HISTORIC PRESERVATION COMMISSION

JULY 23, 2020

To: Historic Preservation Commission
From: Peter Hughes, Senior Planner
CC: Darryn Burich, Planning and Inspections Director
Kelly Brown, Administrative Specialist
Date: July 14, 2020
Subject: Major COA Request for 605 Linden Road (COA 2020-00079)

To: Historic Preservation Commission
From: Peter Hughes, Senior Planner
CC: Darryn Burich, Planning and Inspections Director
Kelly Brown, Administrative Specialist
Date: July 16, 2020
Subject: Major COA Request for 60 Cherokee Road (COA-2020-00087)

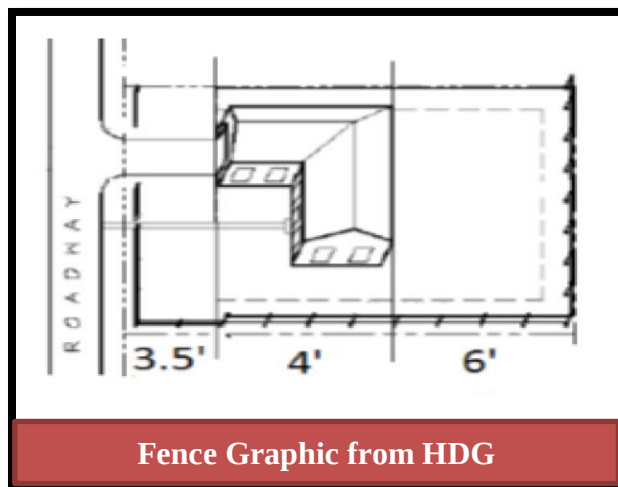
The applicant is proposing a six foot wrought iron fence that will enclose a portion of the defined side yard and entire rear yard of the property. This is a unique request because the existing residence is located within the building setback approximately four feet from the rear property line (measurement from ArcGIS). The building was constructed in the 1970s prior to the current setback regulations and the building exists as an existing non-conformity.

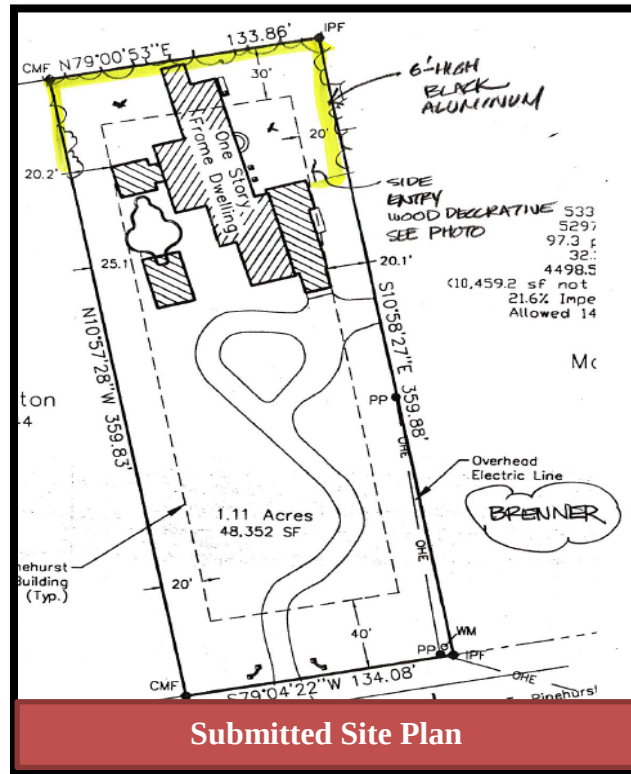
As previously stated the applicant is proposing a six foot, side yard fence. According to the Historic Guideline shown below, side yard fences in the historic district are regulated to be no taller than four feet in height.

The fence graphic above shows the potential and regulated fence layout in the historic district. The graphic illustrates a reasonable or conventional home with a building footprint that easily accommodates a rear, side, and front yard fencing options. However, 605 Linden is a unique lot with a unique building footprint that essentially, leaves the property without a rear yard.

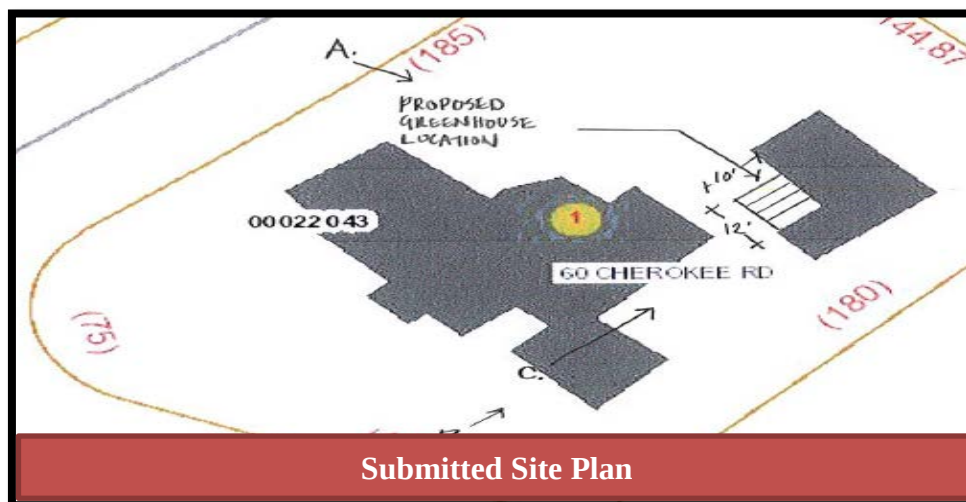
The proposed location of the addition will be located in the rear yard and may be visible from the street, however there is good amount of screen provided from landscaping adjacent to Cherokee Road.

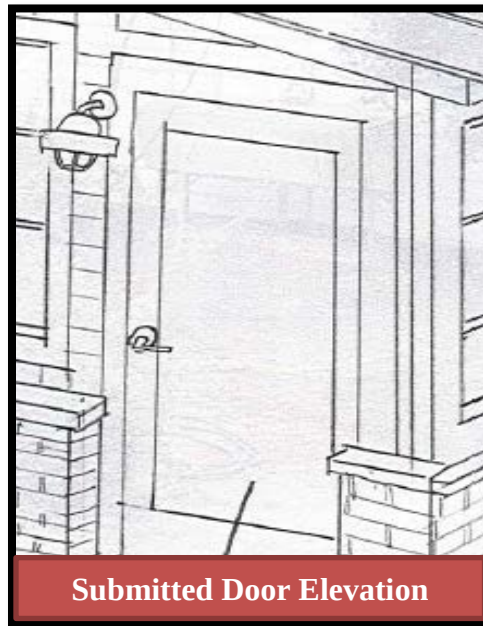
The roofing material is tempered greenhouse glass that will be framed by metal trim. The tempered glass of the greenhouse is not listed as an approved material, however would be acceptable given the desired use of the proposed addition. Staff is aware of other greenhouses within the Historic District, but cannot speak to whether the proposed material is similar to those existing greenhouses.

The door is proposed to be a clad full view door to match existing doors on both the home and accessory structure. The center of the door will be a glass pane window and the trim of the door frame will be wood. Wood and glass are compliant with the Guidelines and are materials that are utilized on other accessory structures within the Historic District.

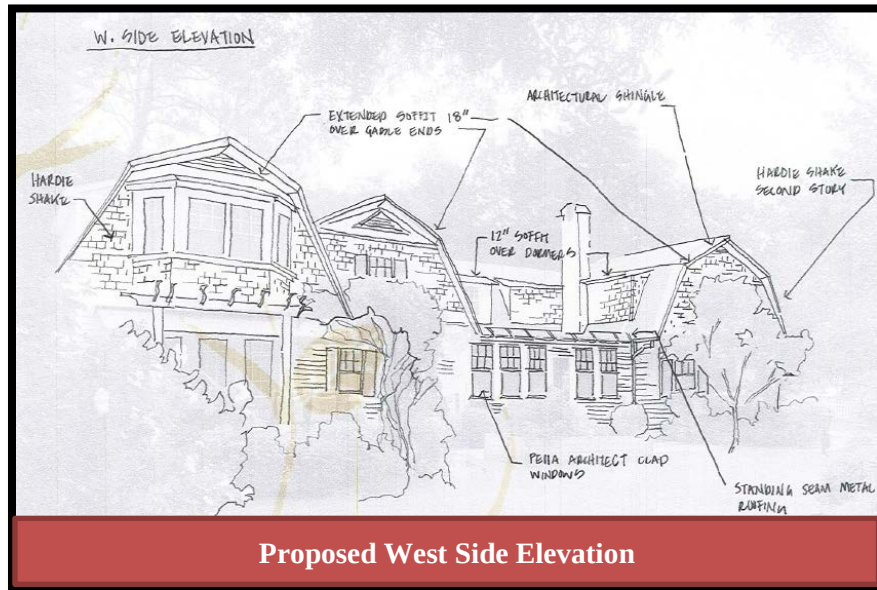
The proposed changes to the front elevation include new hardie siding, with the second story dormers transition to shake siding verses the current lap siding. The reshingling of the existing roof and installation of new metal sealed roof.

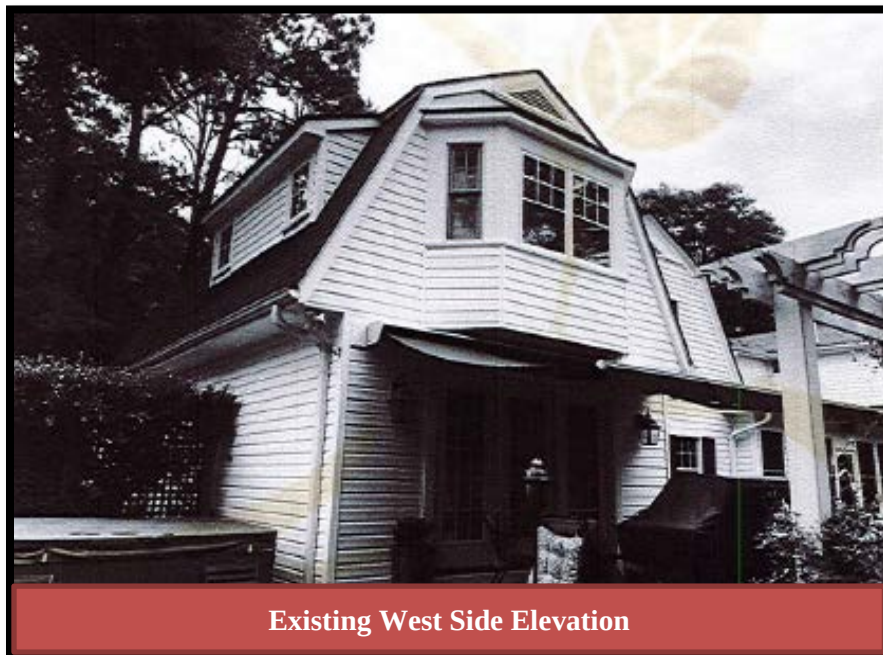
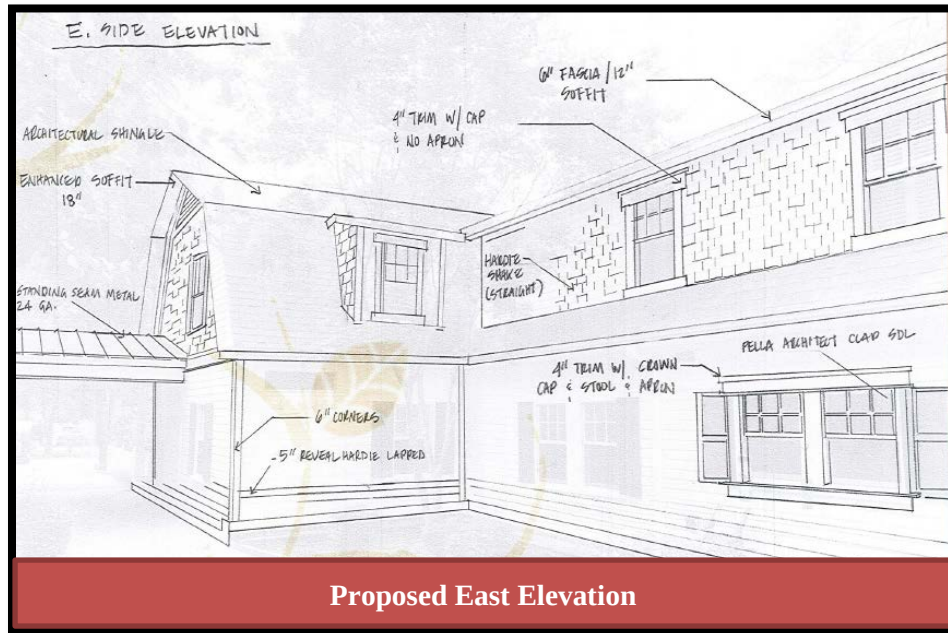
The proposed changes to the west elevation include new hardie siding, with the second story transition to shake siding verses the current lap siding. The extension of current soffits will also occur, which will compliment the current architectural design of the structure.

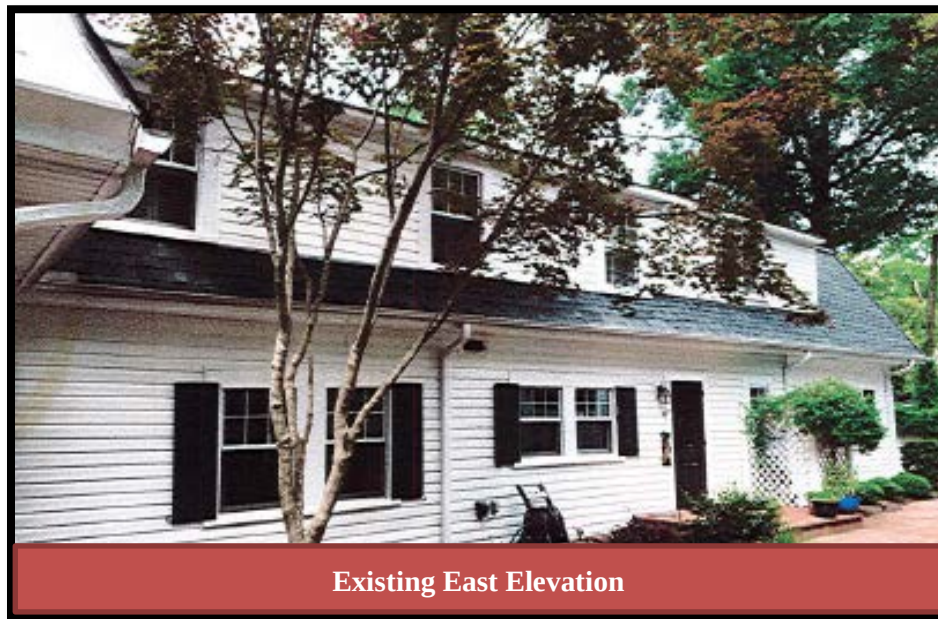
The proposed changes to the east elevation include new hardie siding, with the second story transition to shake siding verses the current lap siding. The extension of current soffits will also occur, which will compliment the current architectural design of the structure. Standing seam metal roof will replace the existing metal roof.

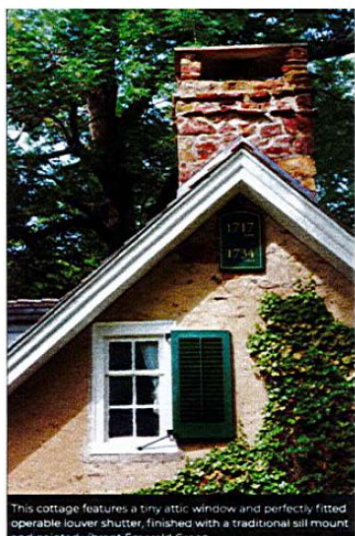
The applicant is proposing shutters on some of the first floor, front elevation windows. The proposed shutters appear to be compatible with the architecture of the structure and windows. The proposed shutters appear to be similar to other shutters within the Historic District

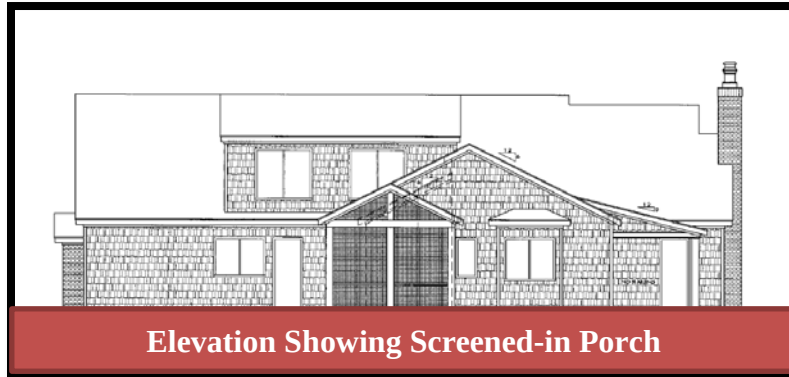
The applicant is proposing multiple accessory features and structures with this application. The primary residential building will feature an attached garage and a rear screened in porch. The garage is not front facing, but could be visible from the street. The screened-in porch could also be visible from the street, given that the lot is a corner lot.

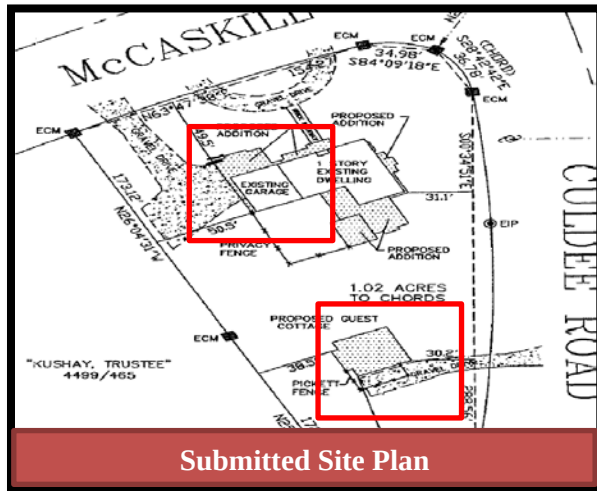
The proposed principle dwelling will be approximately 15' tall (scaled to the top of the chimney) and the proposed accessory structure will be approximately 11' tall. The roofs of both structures have a variety of roof slopes, however they are similar slopes. The principle dwelling features slopes of 12 over 12, 10 over 12, and 6 over 12 and the accessory structure features slopes of 12 over 12, 8 over 12, and 4 over 12. (Refer and review the submitted elevations)

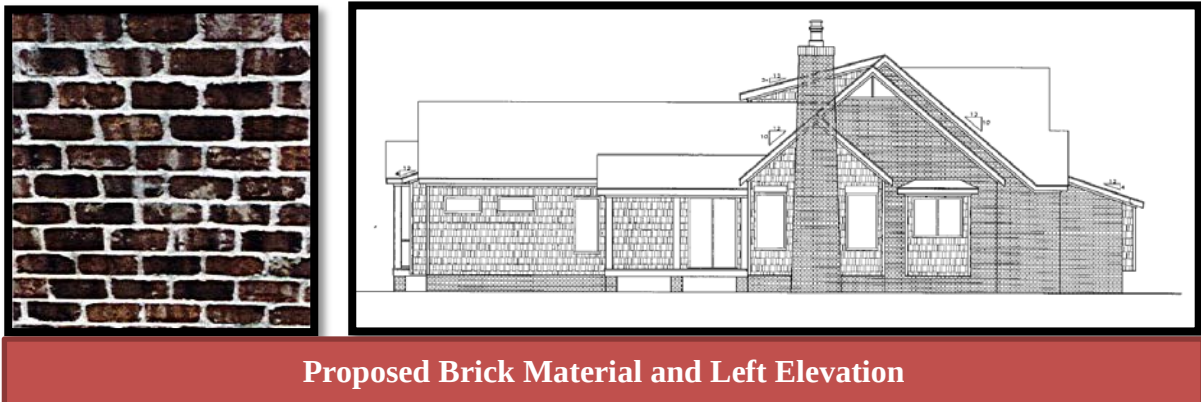
The garage door is proposed to be insulated steel with a faux wood veneer. The proposed garage door is similar to other garage doors within the Historic District and the proposed material is compliant with the Historic District Guidelines.
